Re: Project #6698208-DM-004

Correction Notice #1

Review Type GEO SOILS
Project Address 801 3RD AVE
SEATTLE, WA 98104
Contact Email JON@PERMITCNW.COM
SDCI Reviewer Pao Huang
Reviewer Phone (206) 684-5825
Reviewer Email pao.huang@seattle.gov
Owner D LLC

Re: Addendum #1 - Response to SDCI Correction Notice #1
The Net - Rubble Berm Support of Basement Walls
SDCI Project Number: 6698208-DM-004
19567-01

Per original detail 8/S3
 SECTION AT MARION ST.

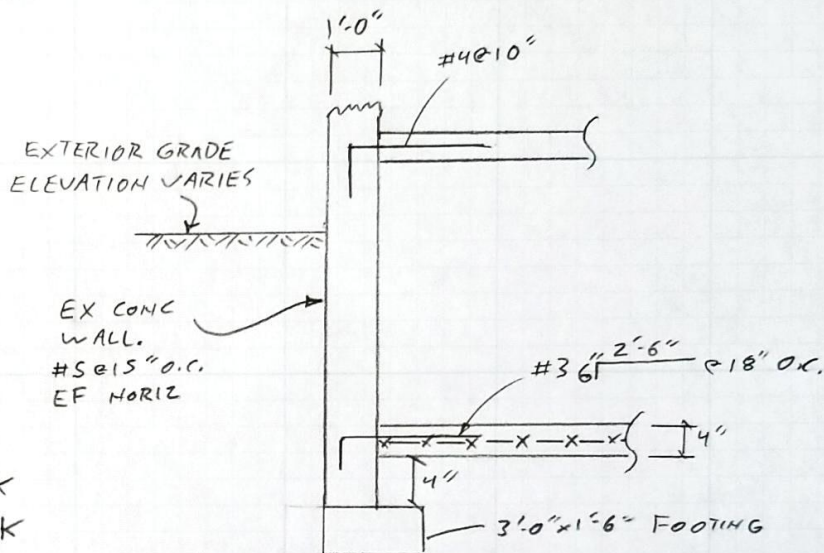
Review comments ask to clarify what provides support for diaphragm reactions for temporary condition shown on calculation page 7 of 17 of original submittal.

Reaction per previous calculations is
 $V_u = 158K$

Friction @ Base = $(0.9 \cdot 203K) \cdot 0.4 = 73K$

Friction on side of wall
 $= (0.9 \cdot 121K) \cdot 0.3 = 33K$

friction at bottom of s.o.g. = $(0.9 \cdot 316K) \cdot 0.4 = 114K$

Total = $73K + 33K + 114K = 220K$ (OK)

Per original details 1&2/S2
section at 823-801 Boundary

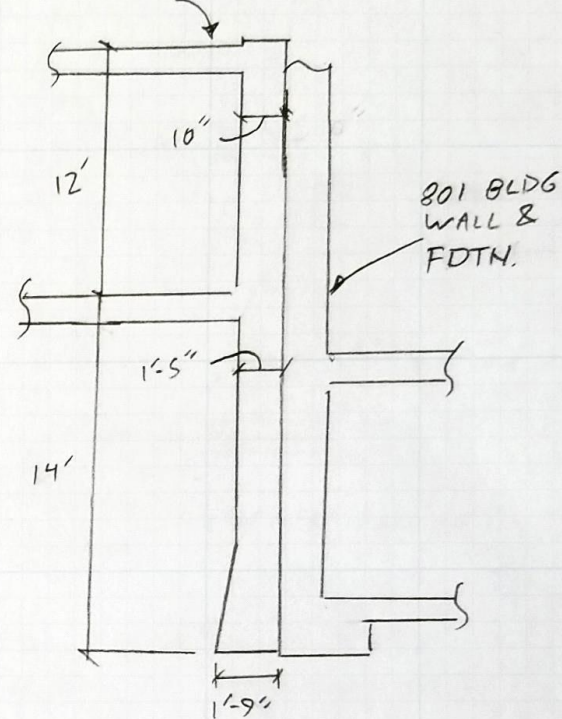
What provides resistance to diaphragm at boundary between 823 3rd Ave building and 801 3rd Ave building in temporary condition.

$$= V_u = 158 \text{ K}$$

$$\text{Friction} = (0.9 \cdot 483 \text{ K}) \cdot 0.4 = 174 \text{ K} \quad (\text{OK})$$

additional mechanisms for resisting forces from diaphragm exist but do not need to be quantified because friction on the base of the existing basement wall is adequate by itself.
